East Midlands Gateway  
Phase 2 (EMG2)

Document DCO 7.8/MCO 7.8

# PRTM 2023 Sensitivity Test Technical Note and Local Road Network Impact Assessment Note

**PRTM 2023 SENSITIVITY TEST TECHNICAL NOTE  
AND LOCAL ROAD NETWORK IMPACT  
ASSESSMENT NOTE  
(DOCUMENT DCO 7.8/MCO 7.8)**

**Figure 4.9: Forecast Flow Change for 2028 With Mitigation minus Core**

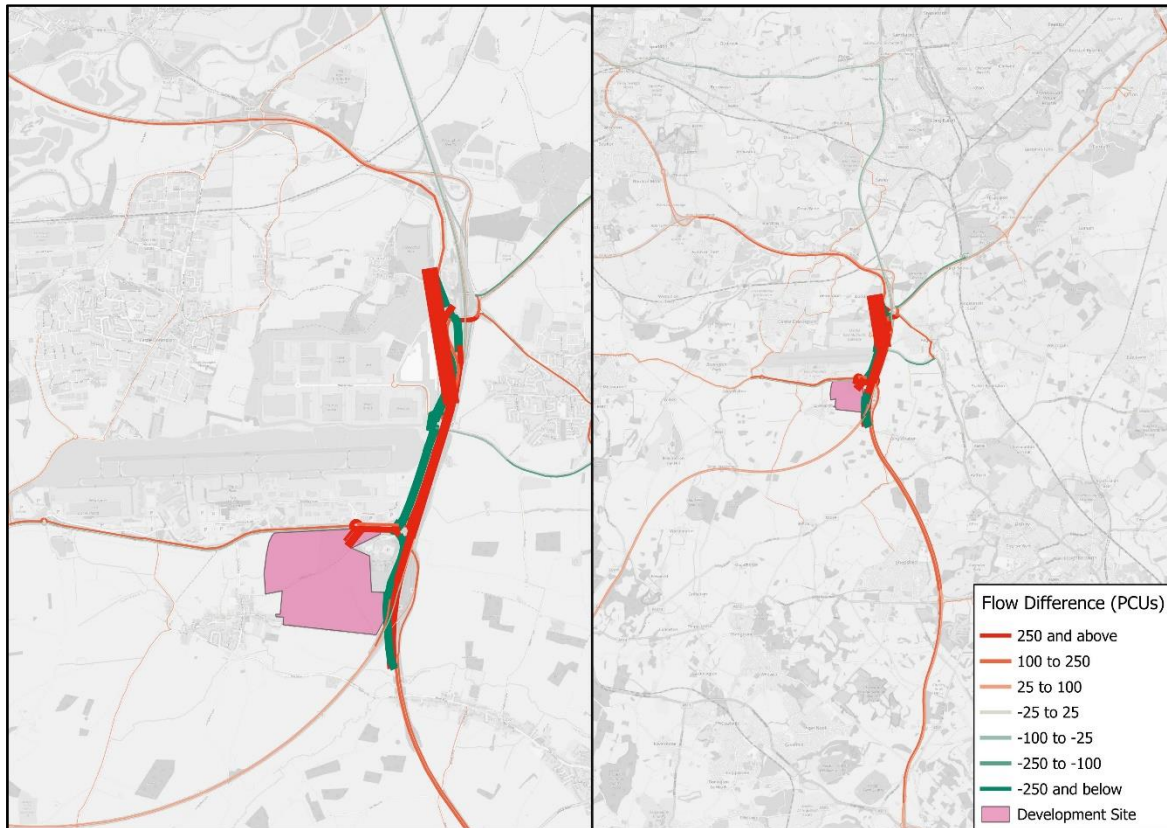
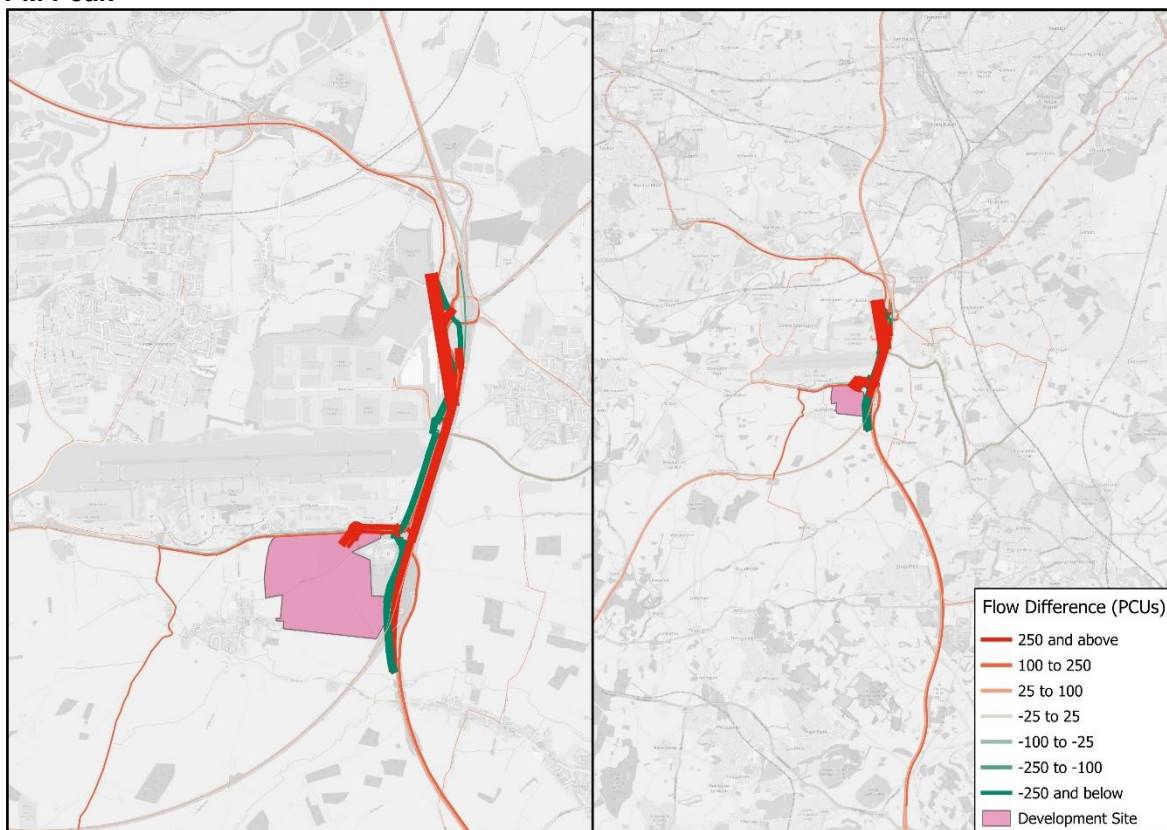
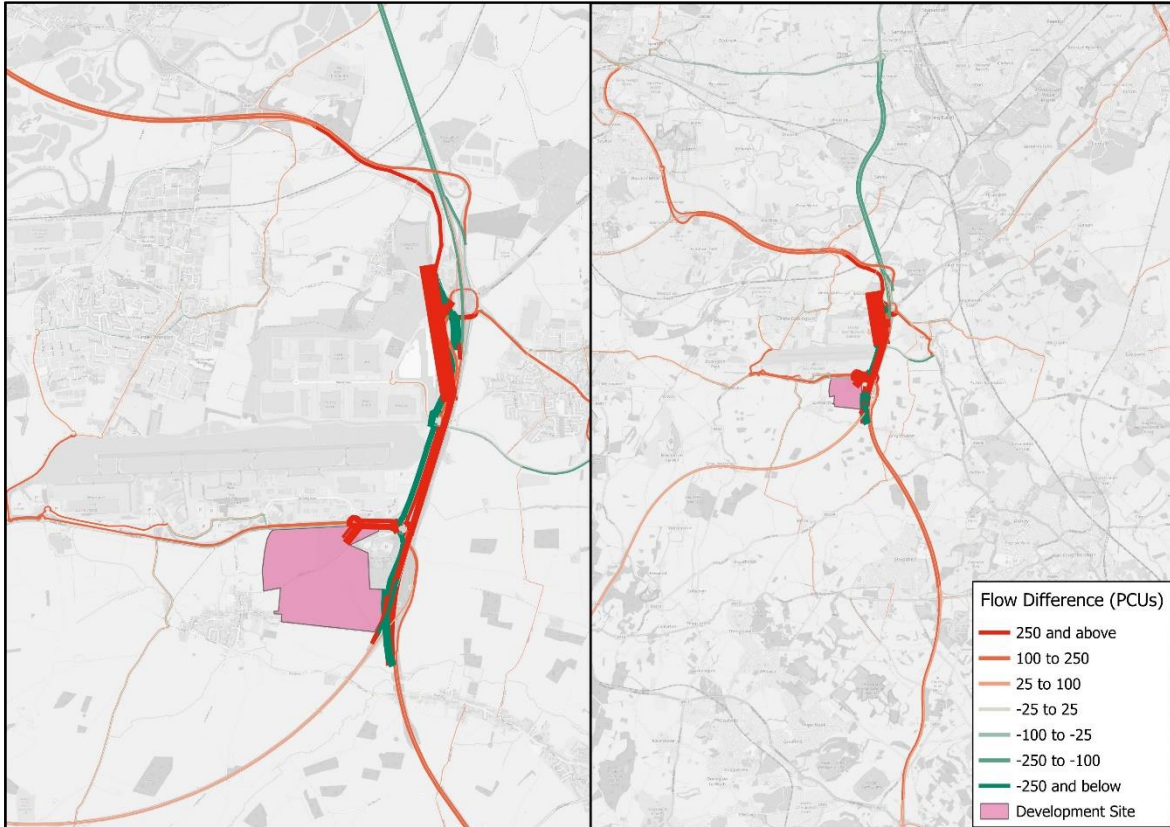
The M1 J24 northbound off-slip indicates a curious change which coincides with a significant decrease in traffic as seen in Figures 4.9 and 4.10 of the report. The table above suggests the VC actually increases following the introduction of the mitigation including the new bypass. There are some significant decreases of VC on circulatory sections of M1 J24 which could suggest either some signal adjustments with the scheme in place or an individual turn overstating these impacts.

**Figure 4.12: Forecast Delay Change for 2028 With Mitigation minus Core**

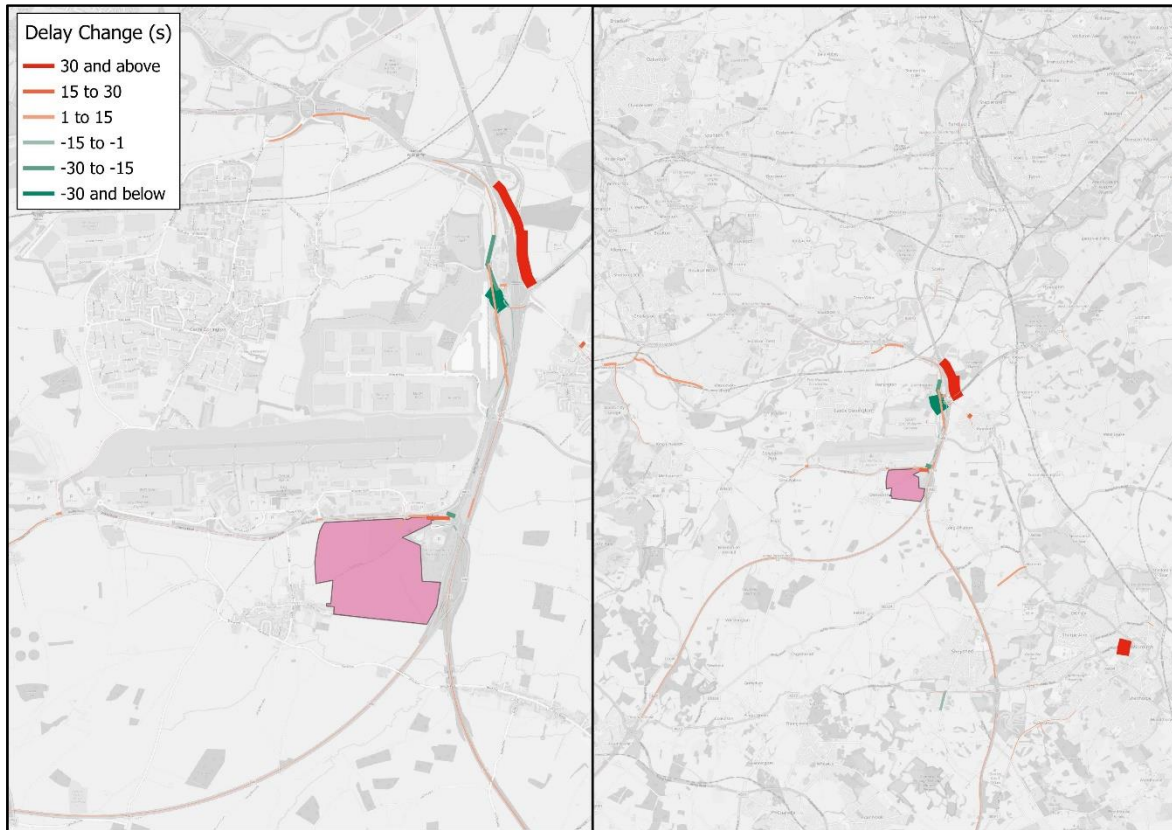
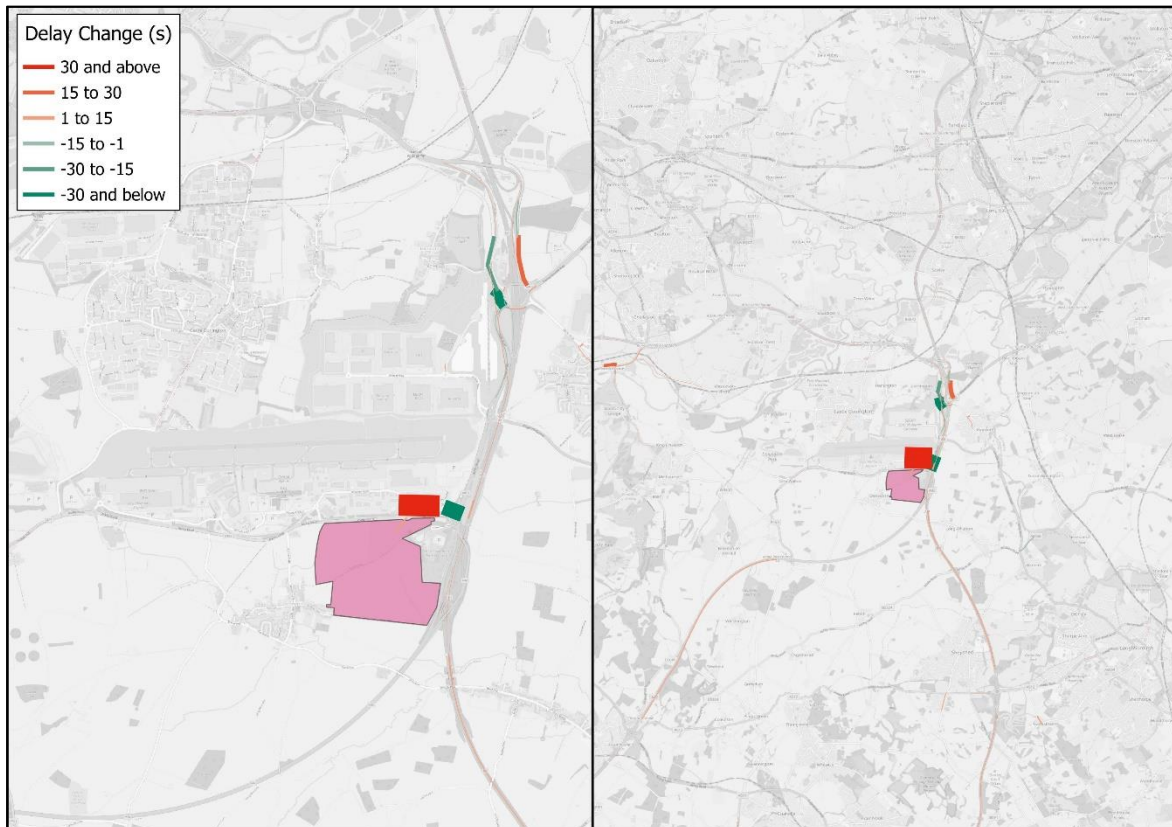
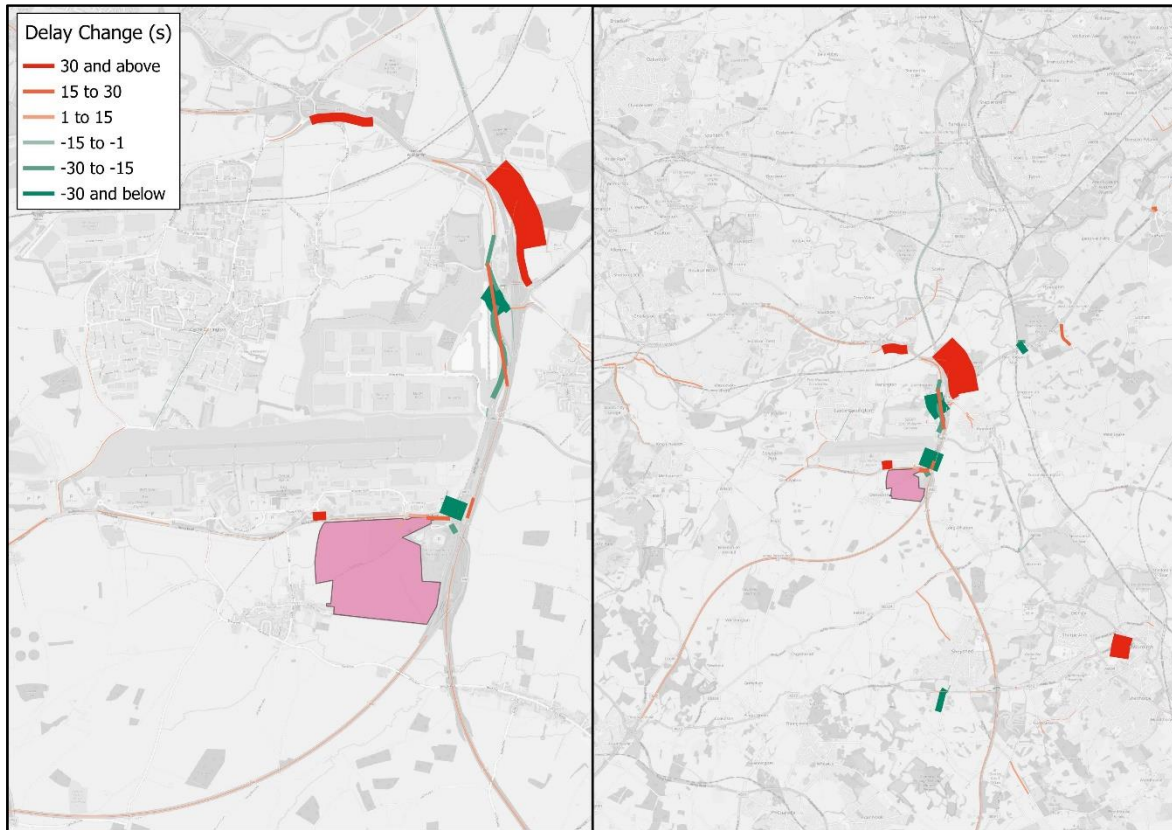
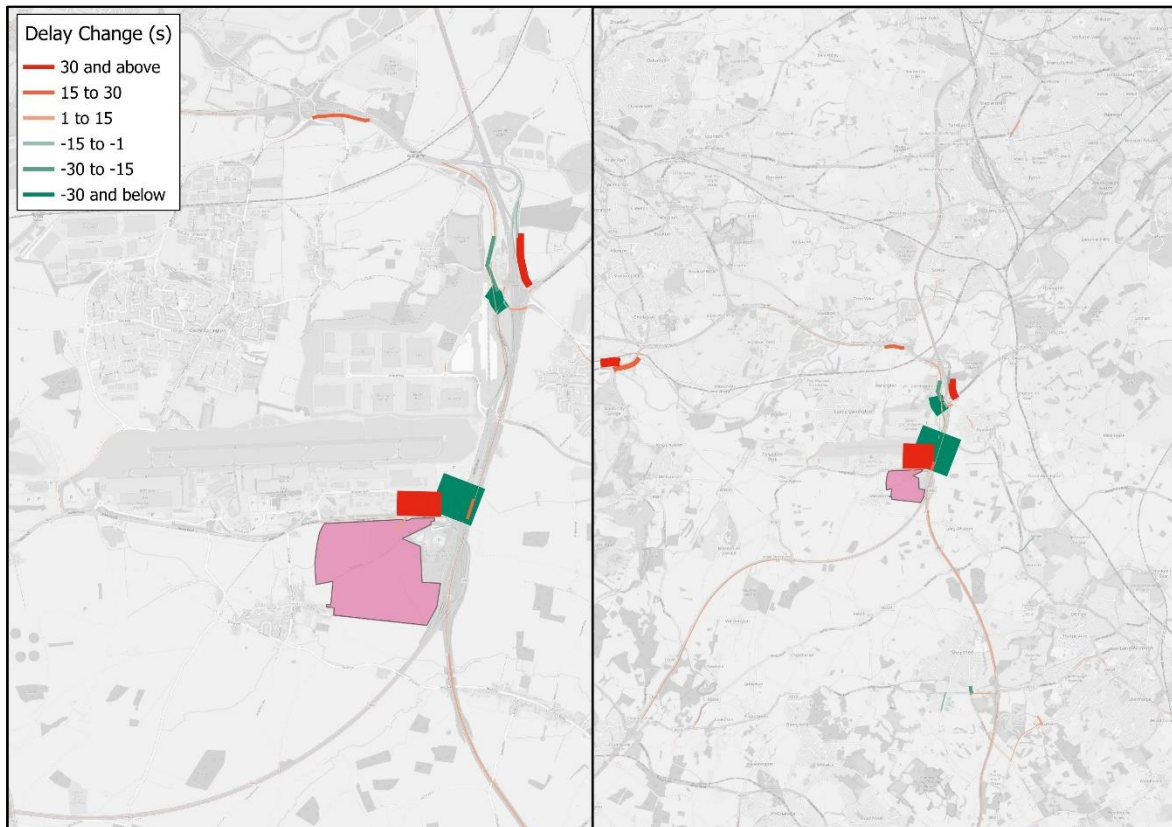
AECOM have confirmed that no signal time adjustments has been made. In reality, the traffic signals are adaptive and more green time would be given to the circulatory. It is notable that Figures 4.12 and 4.13 do not show any major delay increases in this area, so the increases are not associated with significant queuing implications in the traffic model.

Figure 1: M1 J24 NB Off-slip area 2028 AM peak VC

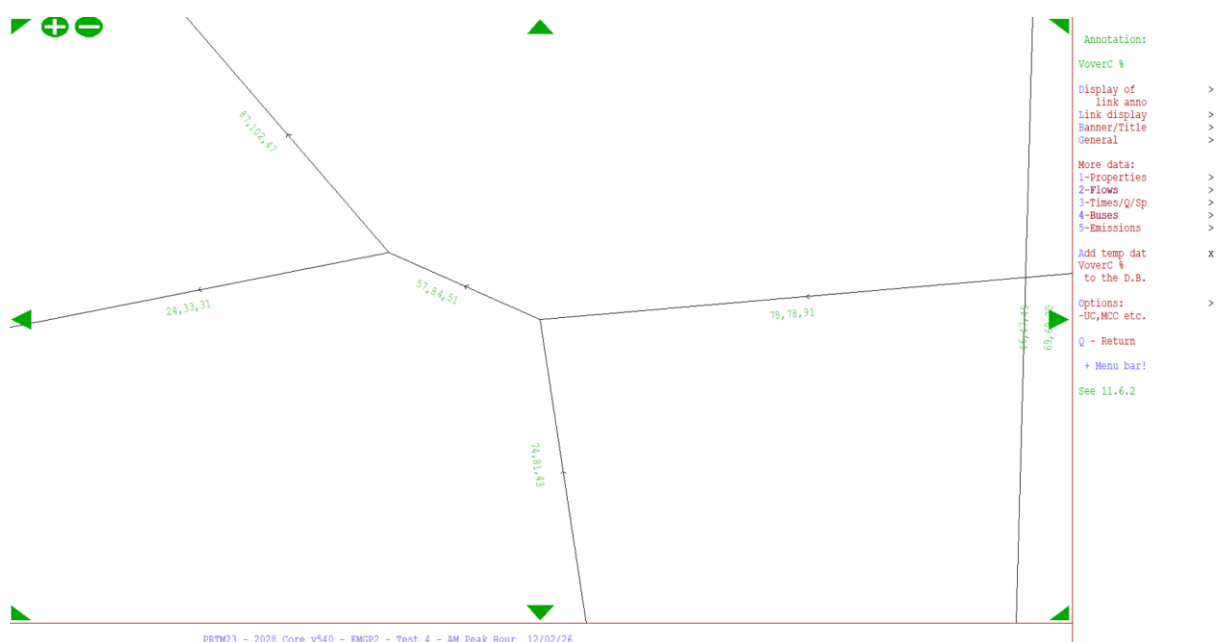
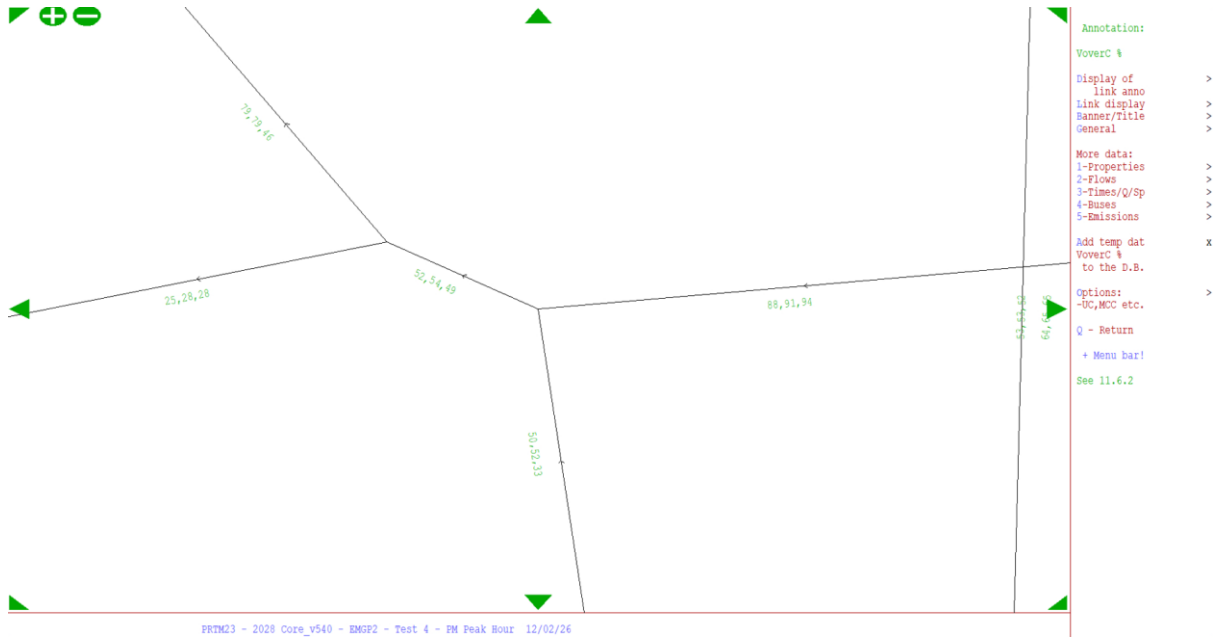
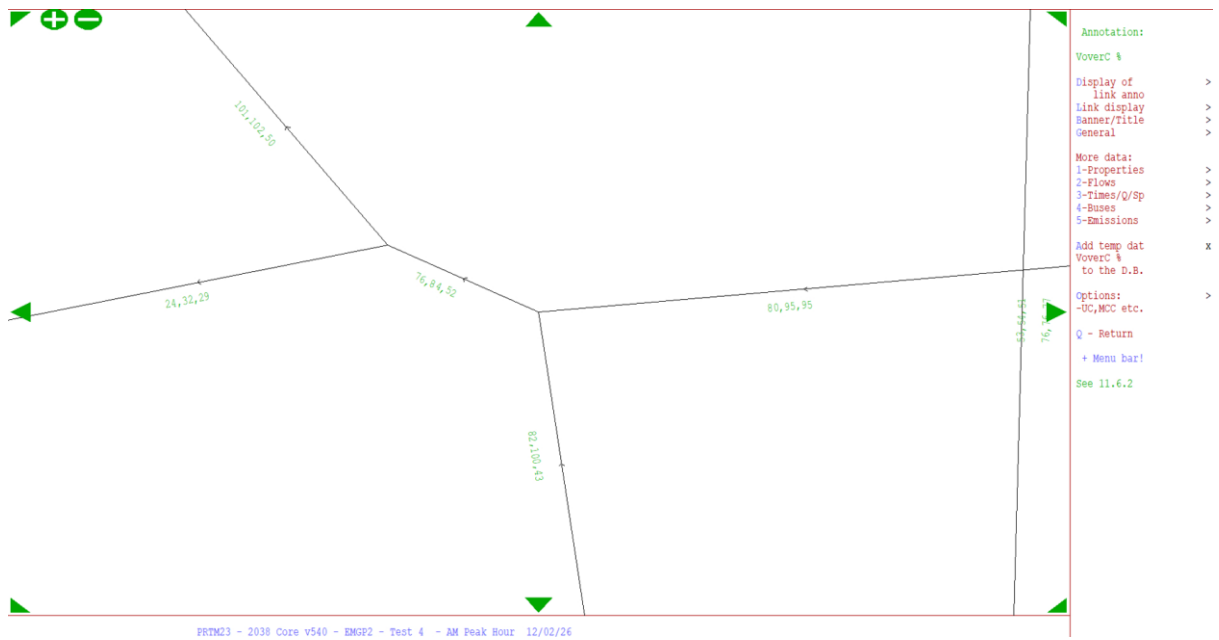
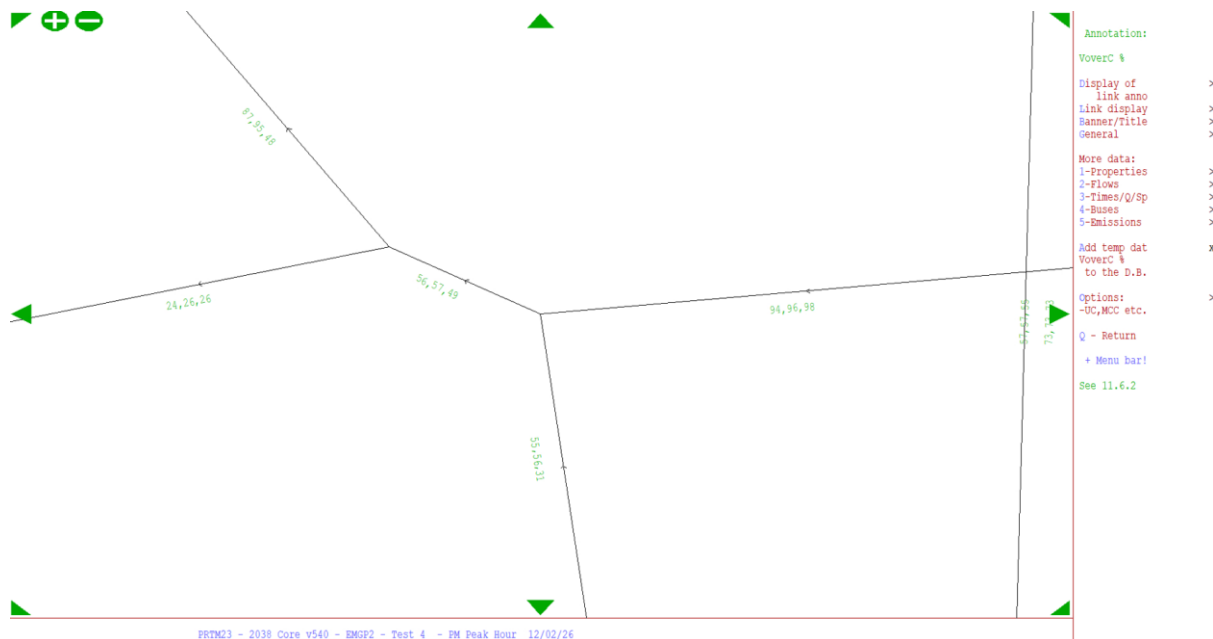
Further examination of the M1 northbound off-slip and the southern section of the circulatory section has been undertaken. JSJV requested VC plots by link for each scenario. These are shown below:-
